PLANNING COMMISSION MEETING
Monday, July 10, 2023 – 7:00 p.m.
City Council Chambers
23600 Liberty Street
Farmington, MI 48335

RE: Legion Square – PUD Site Plan Review #1
 31775 Grand River Avenue
 Proposed Zoning: PUD – Planned Unit Development

RE: Legion Square – PUD/Site Plan Review #1
31775 Grand River Avenue

TRUCK TURNING PLAN
 CERVY CONSTRUCTION, L.L.C.
 CLIENT:
 31775 GRAND RIVER AVENUE - PARCEL NO. 23-27-476-007
 TOWNSHIP 1 N
 RANGE 9 E
 SECTION 27
 OAKLAND COUNTY
 MICHIGAN

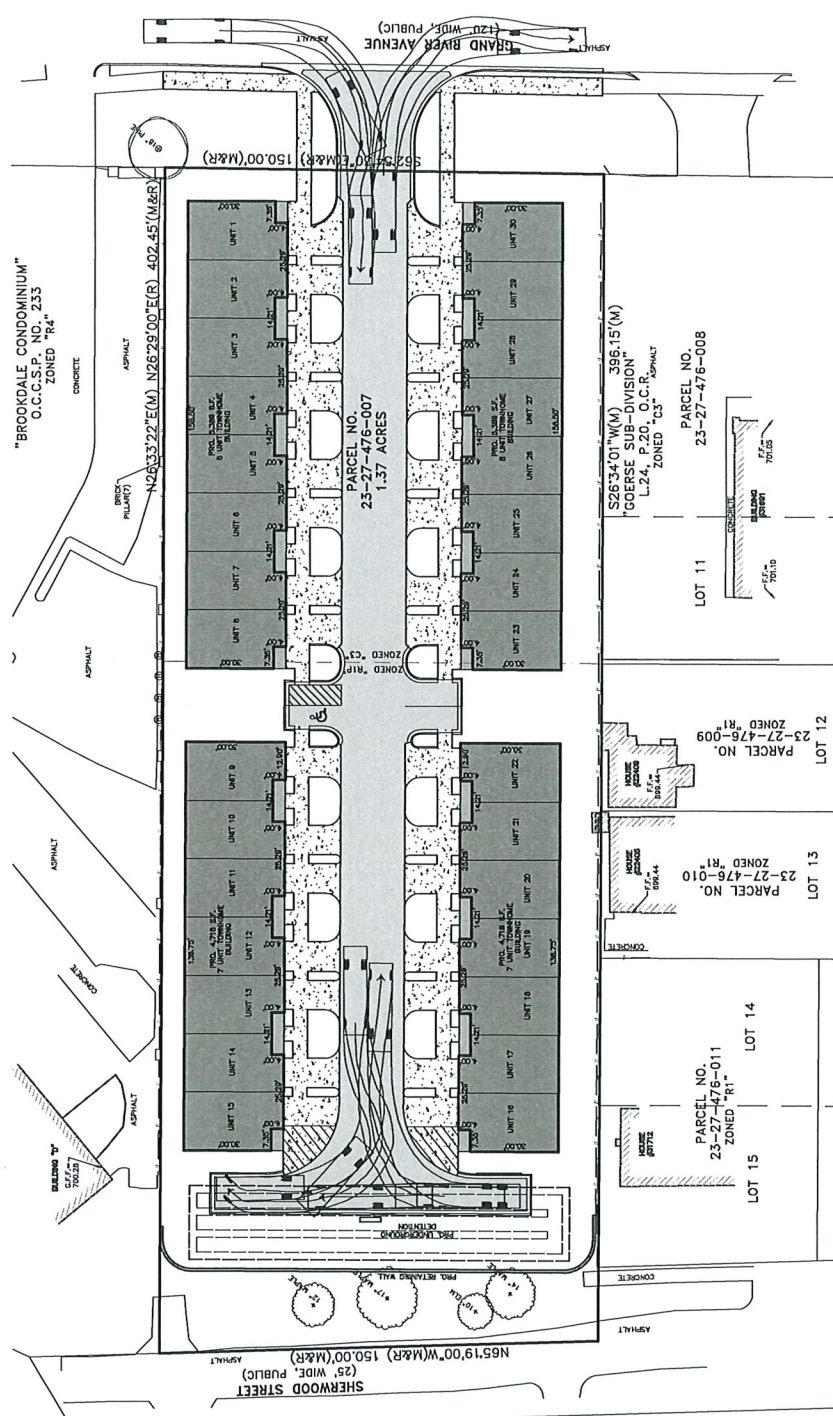
3. A representation of how a garbage truck, or the largest anticipated vehicle, will access the proposed site shall be provided. It is recommended an AutoTurn turning template be added to the plans prior to future submittals. The applicant may want to consider dumpster enclosure(s) versus roll off pick up.

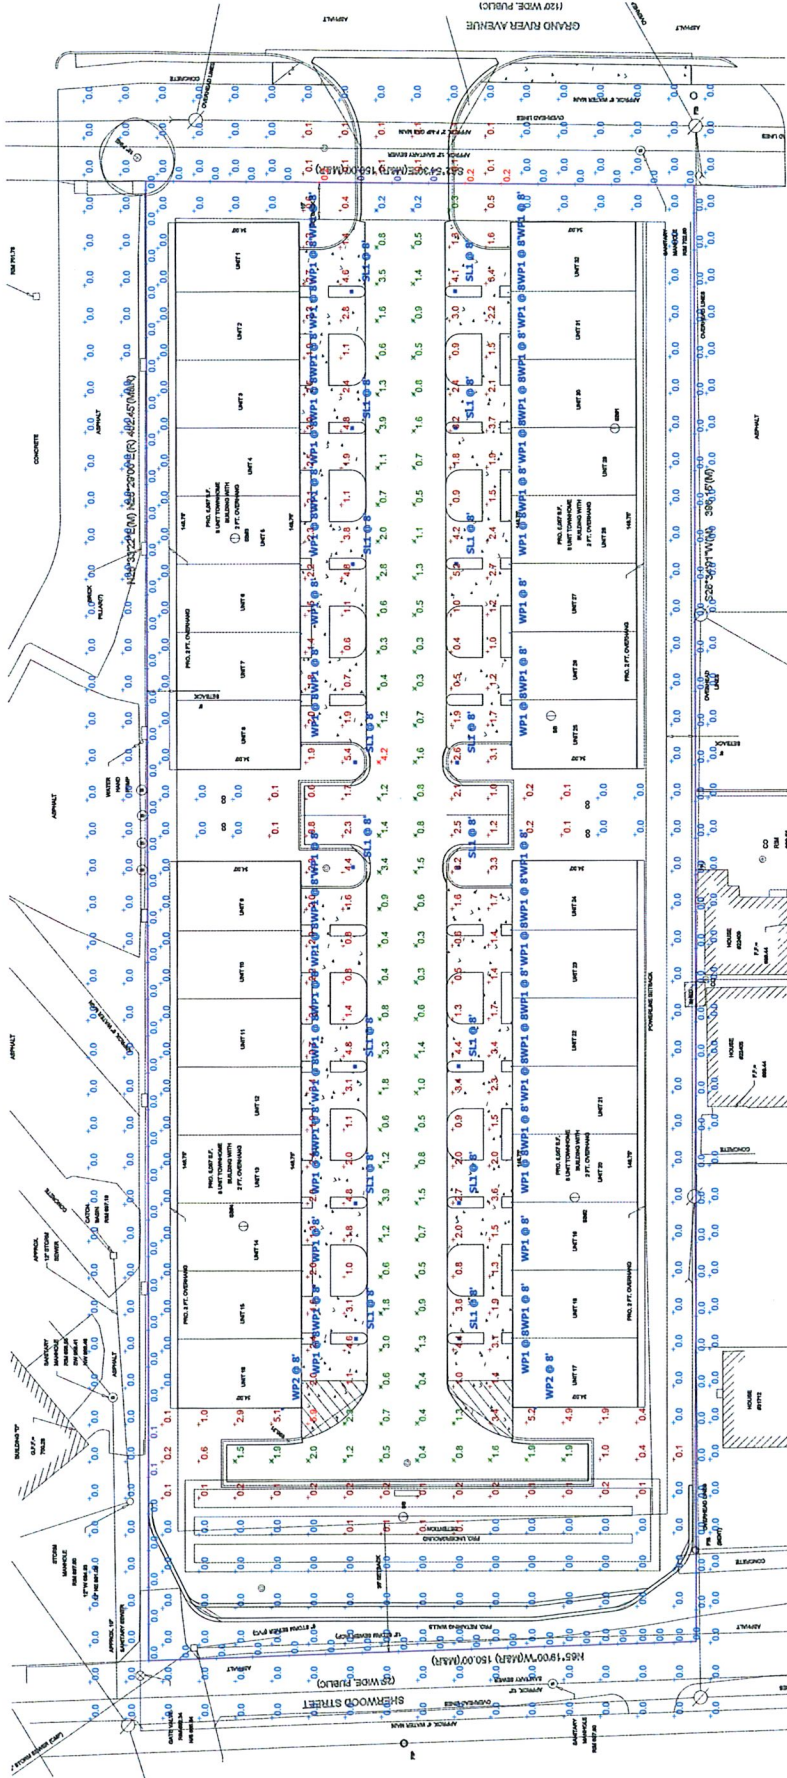
- G. Lighting – The majority of the proposed lighting results in photometric levels of at or near 0 along all property lines. While there are only 4 pole mounted fixtures, their height still need to be denoted on the plans.

9. The pole height need to be denoted on the plans.

FRONT ELEVATION - 8 UNIT BUILDING
SCALE: 3/16" = 1'-0"

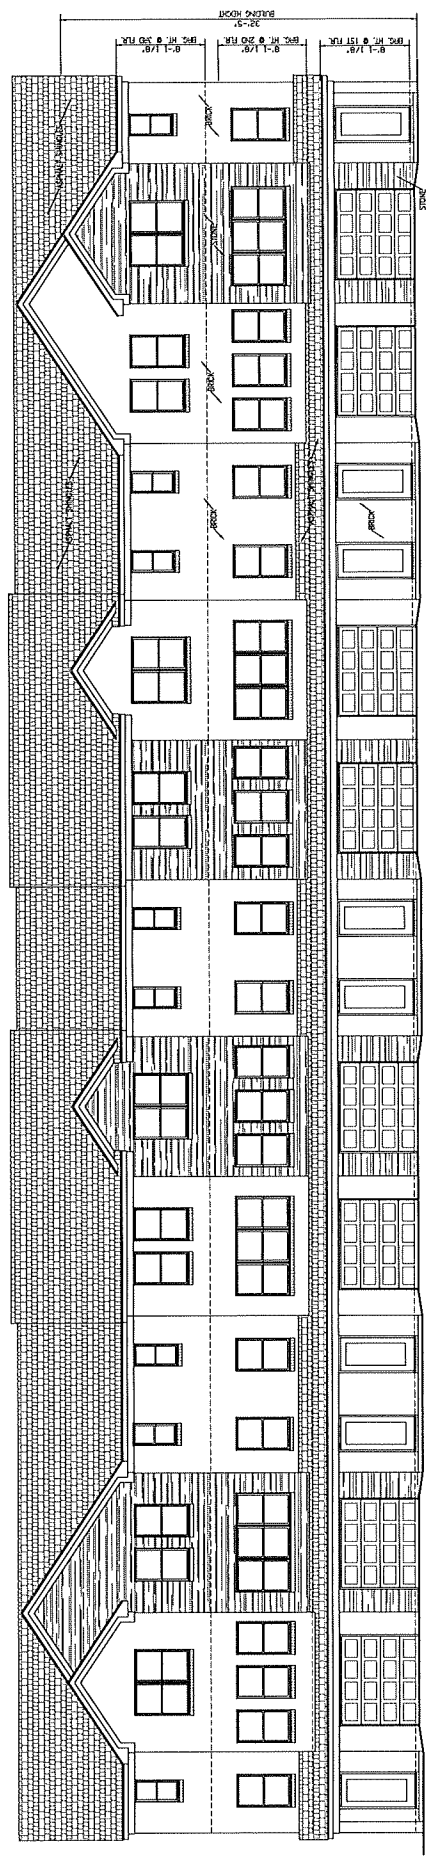
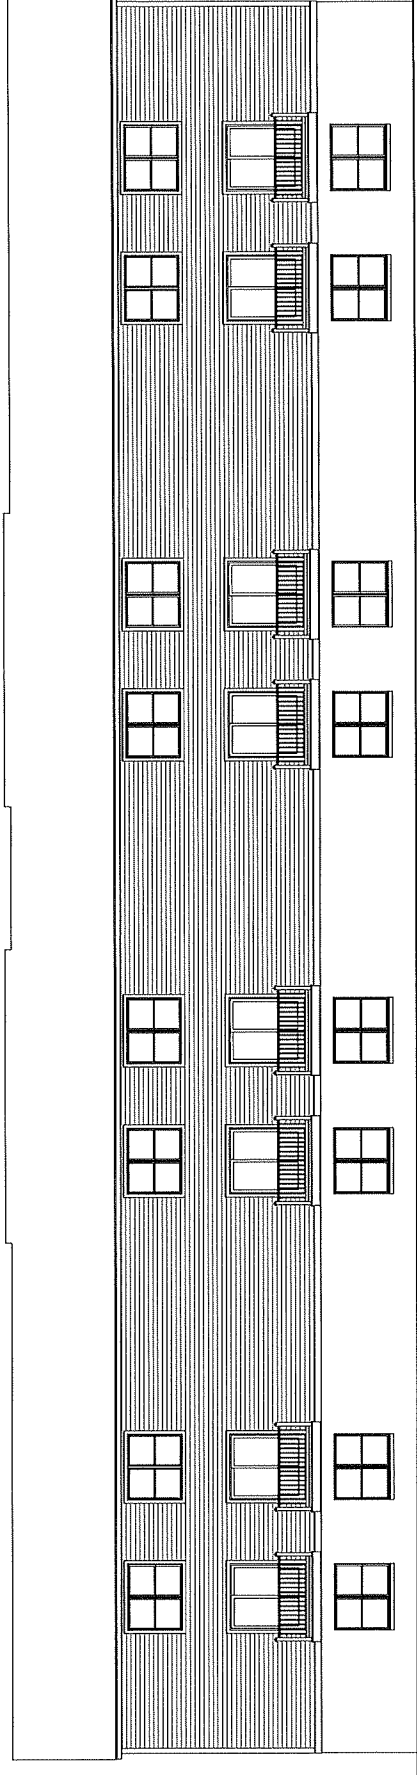
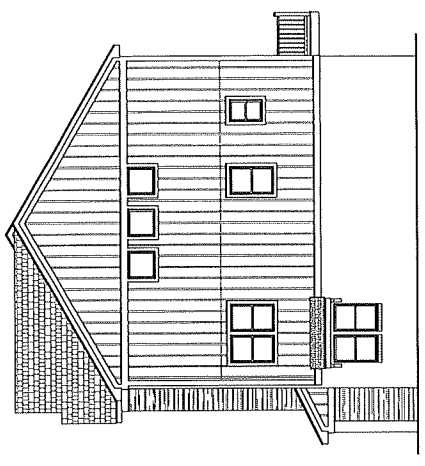
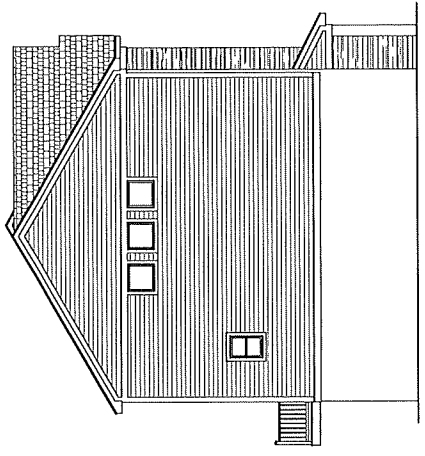
1. Provide detailed and colored renderings for all 4 building facades to ensure compliance with the noted intention to provide enhanced quality of the architecture.
2. Mitigation of offsite impacts are being addressed through on-site stormwater retention via an underground storm detention system (defer to the Engineering review) and impacts on the abutting residential development are limited due to the proposed dead-end street.
